Elevation Plans_V1.pdf Markup Summary

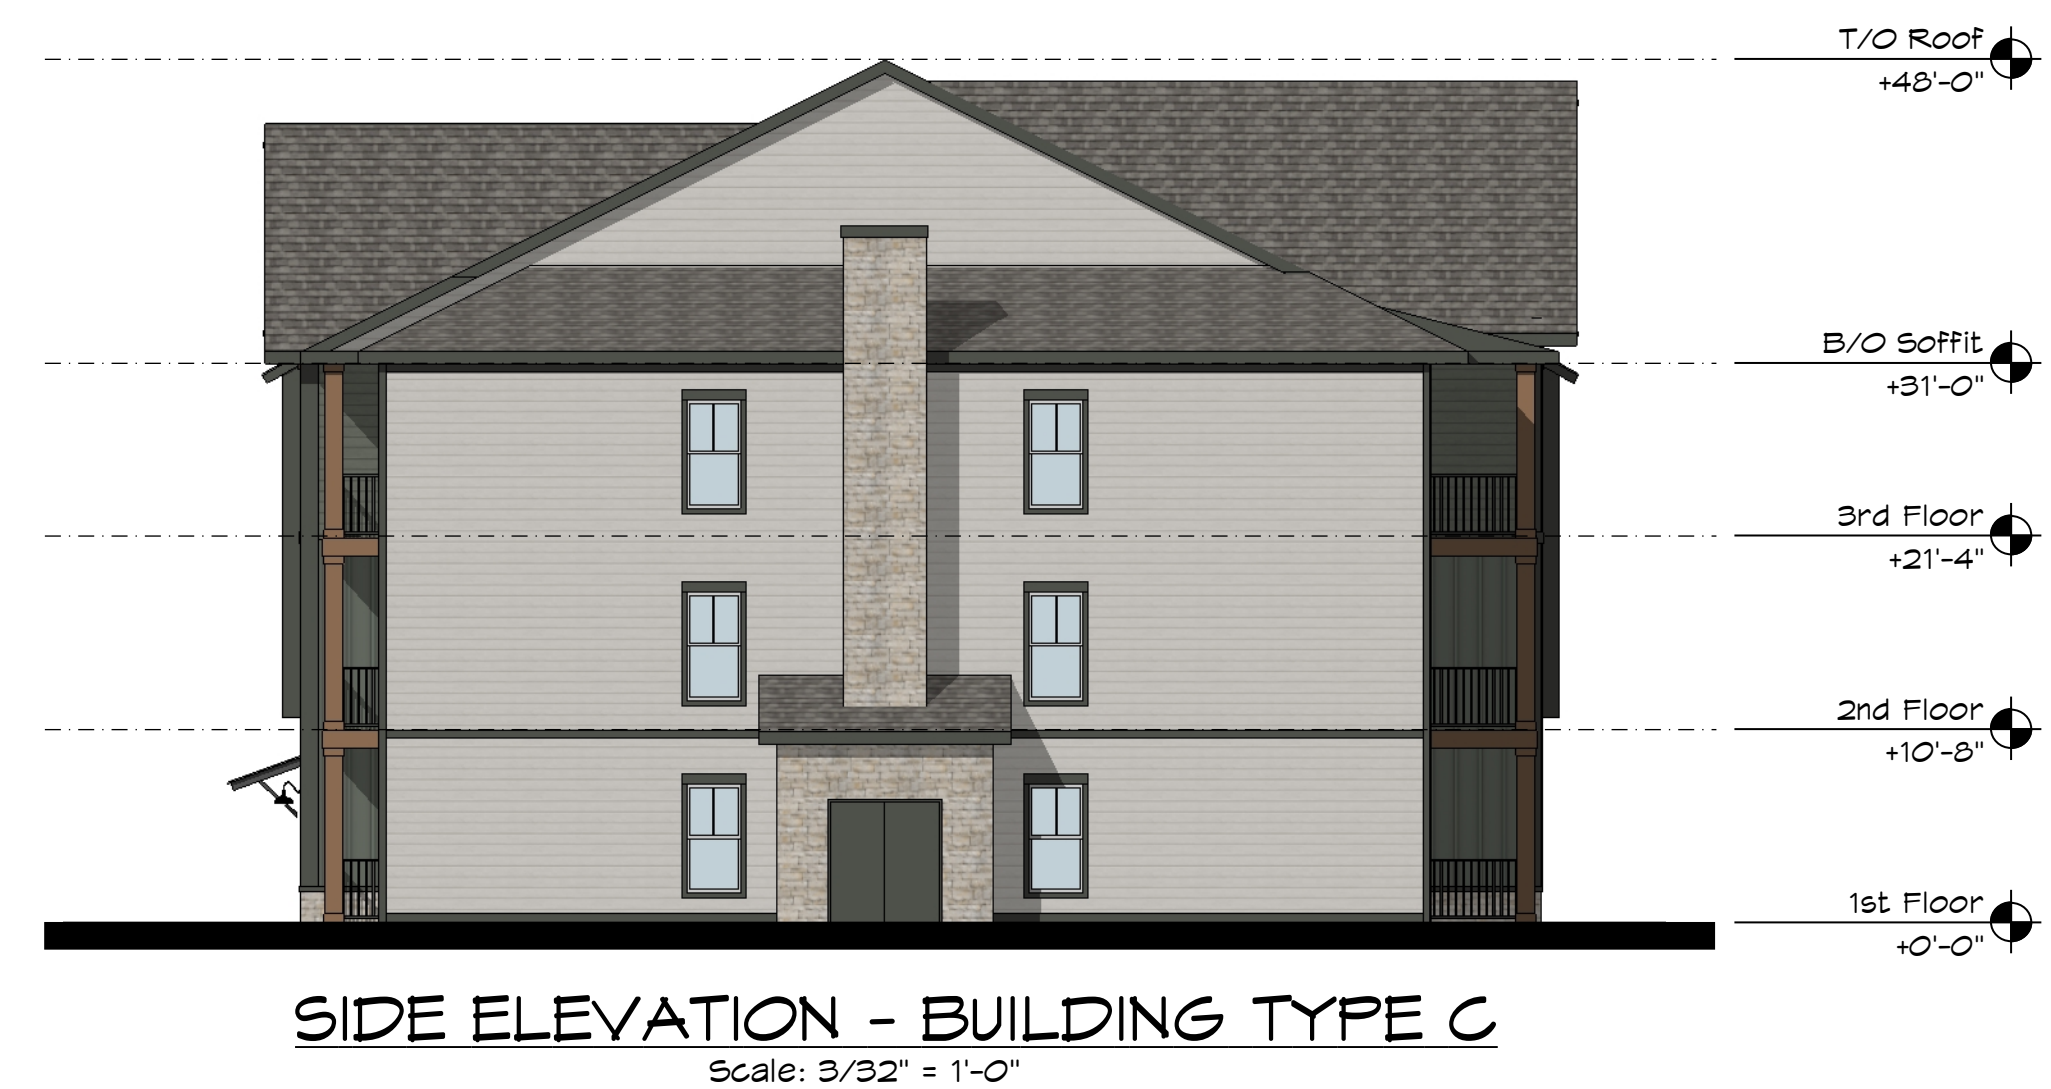
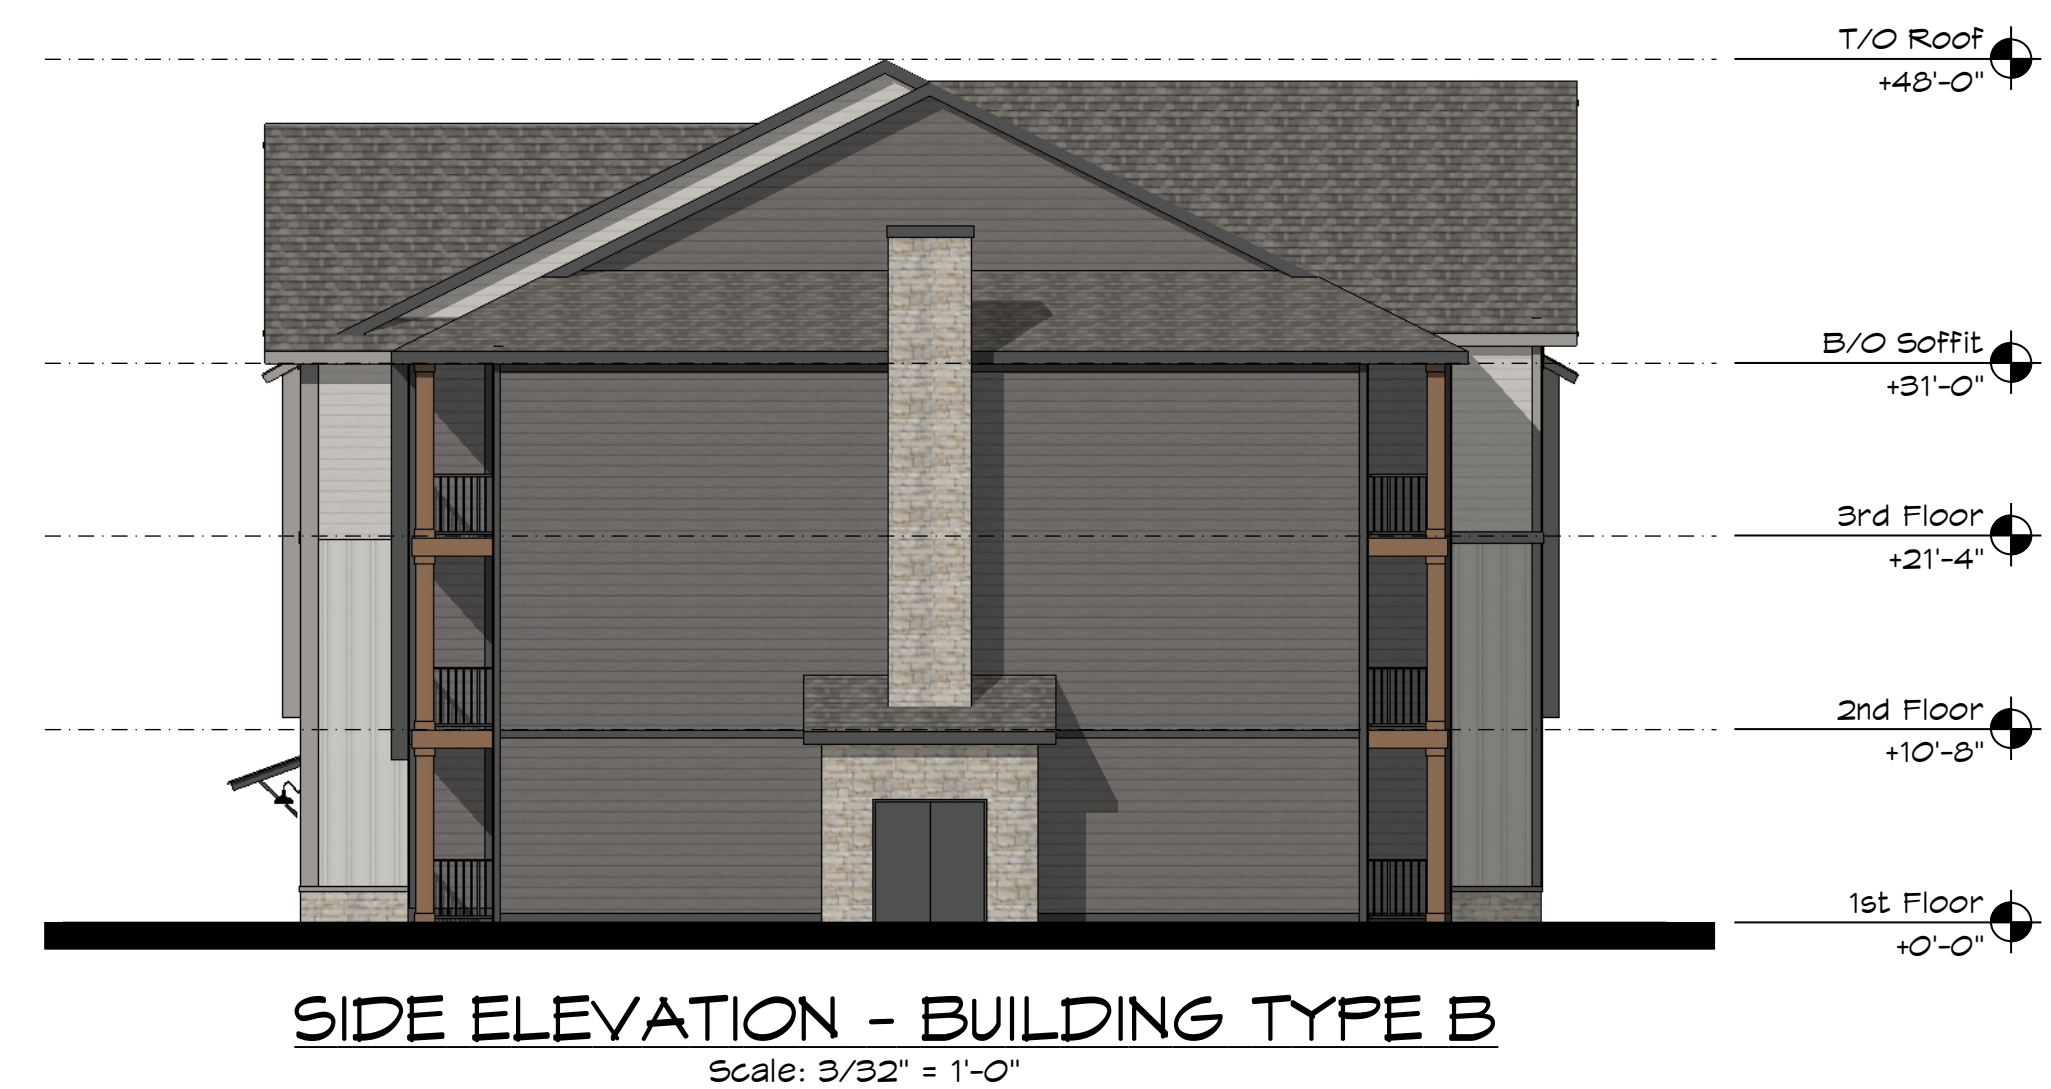
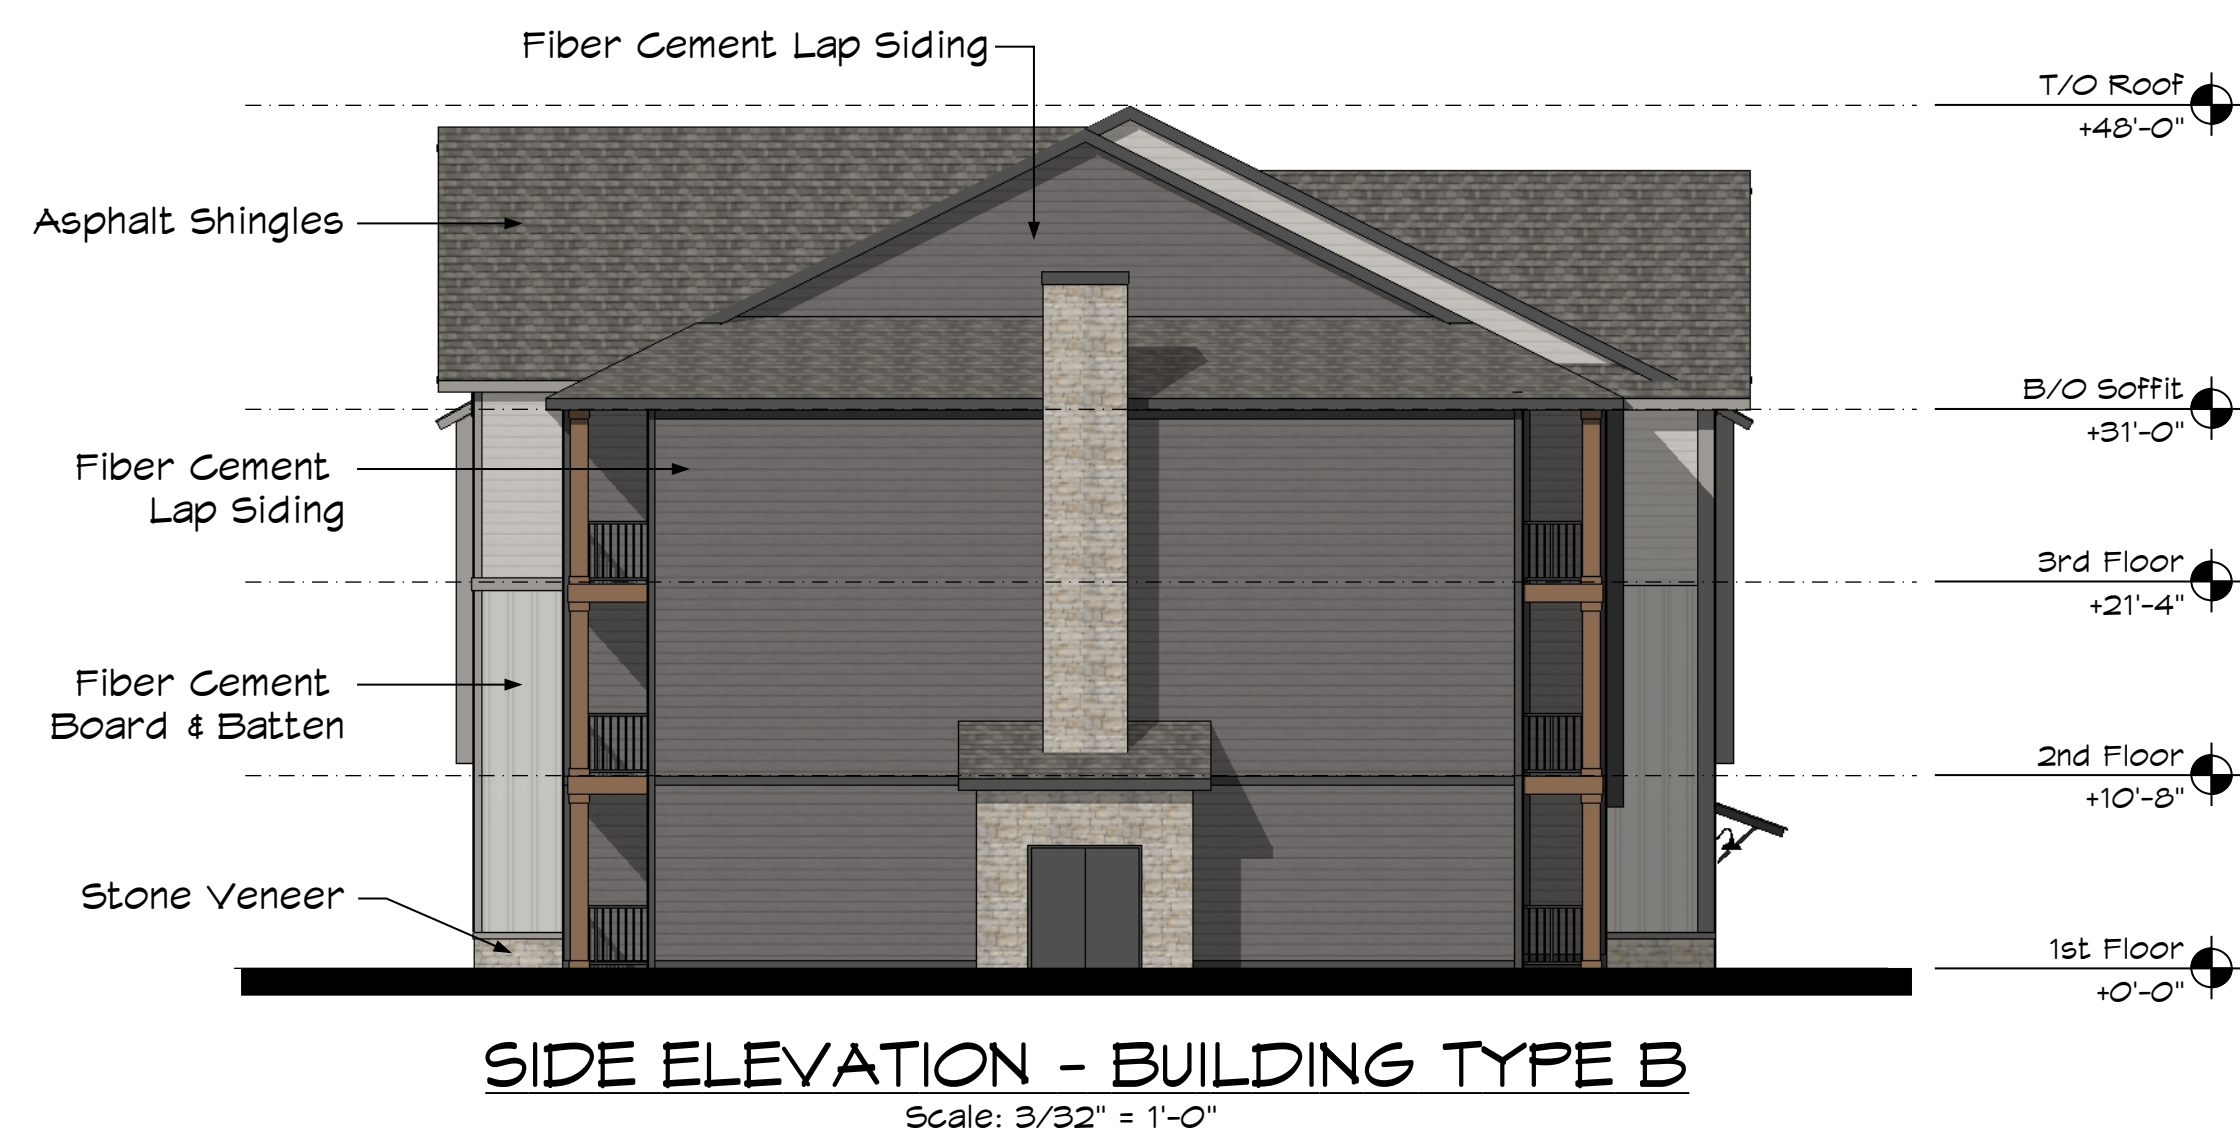
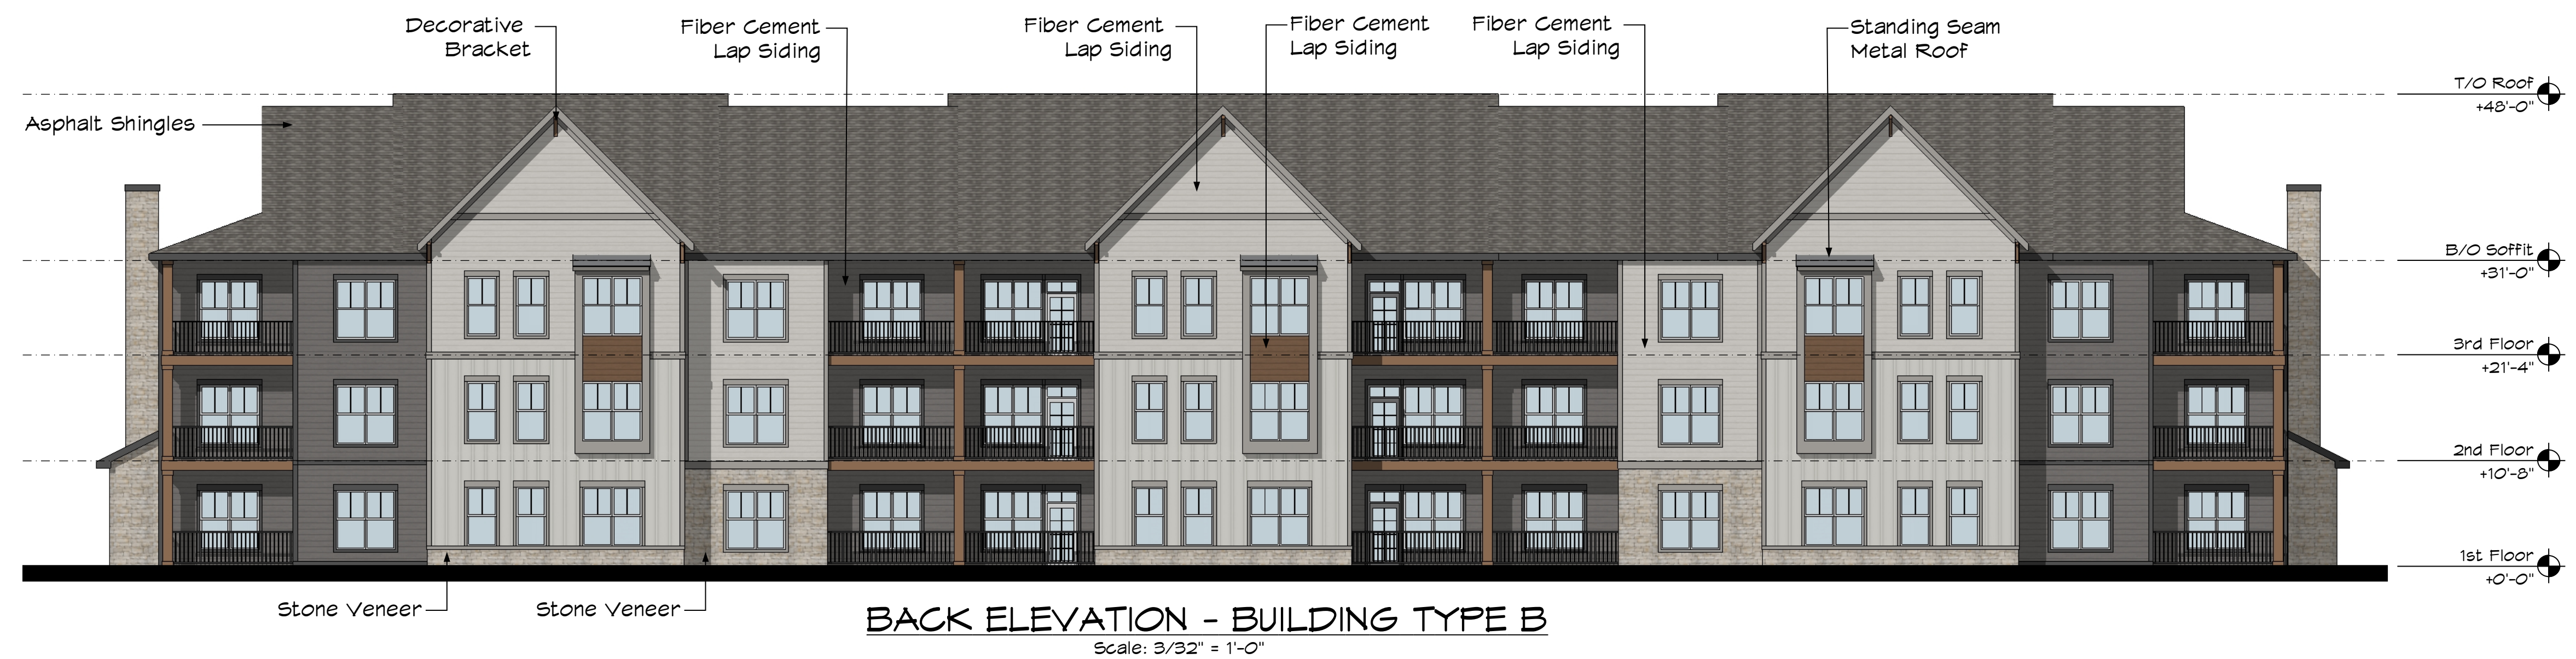
Because allowed building height is max. 40 height, please show the average roof height to demonstrate that the 48' to top of roof-line still meets the height limitations.
